# ERRATA SHEET

**Date:** 2008 Mar 10  
**Document Release:** Version 1.2  
**Device Affected:** P89LPC907

Figure 1: Flowchart ICP Global Erase

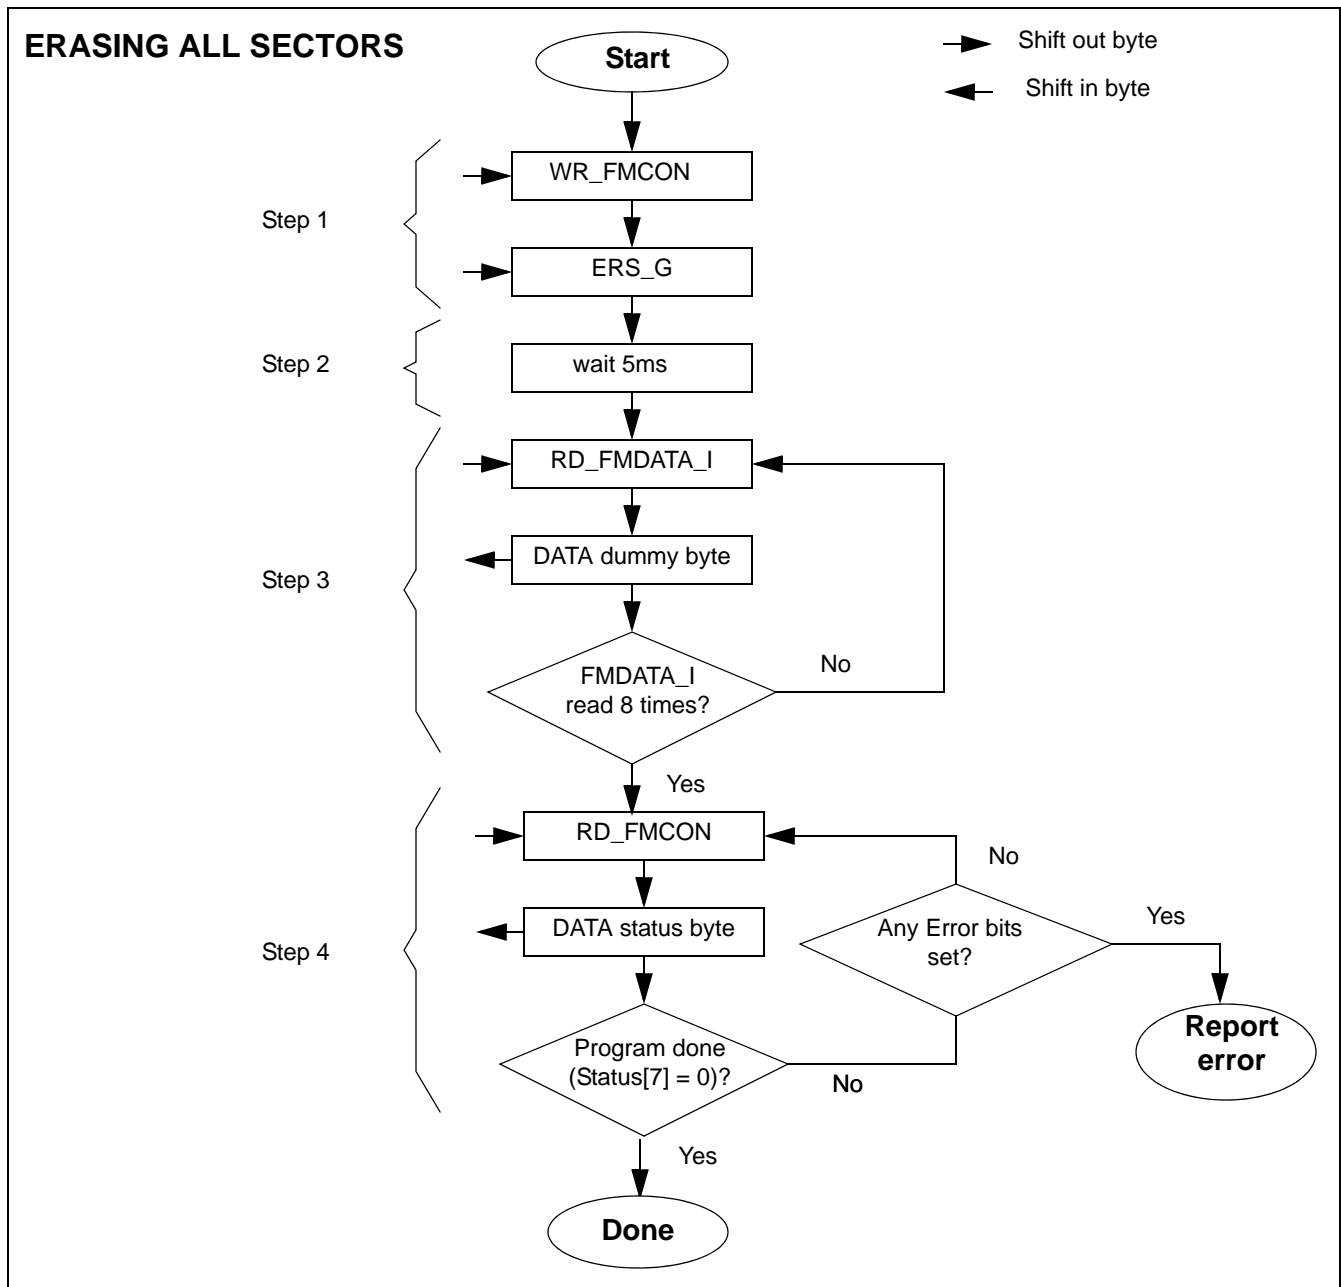
**Problem:** When giving the Erase Global command through the ICP interface the LPC907 will not clear the busy flag and stay busy forever.

**Workaround:** The workaround can be done in 4 steps:

Step 1: Shift out the WR\_FMCON command followed by the Erase Global opcode.

Step 2: Wait 5ms.

Step 3: Do 8 dummy reads with the RD\_FMDATA\_I command.

Step 4: Read FMCON until the busy flag gets cleared.

Please also see figure 1 on the following page.
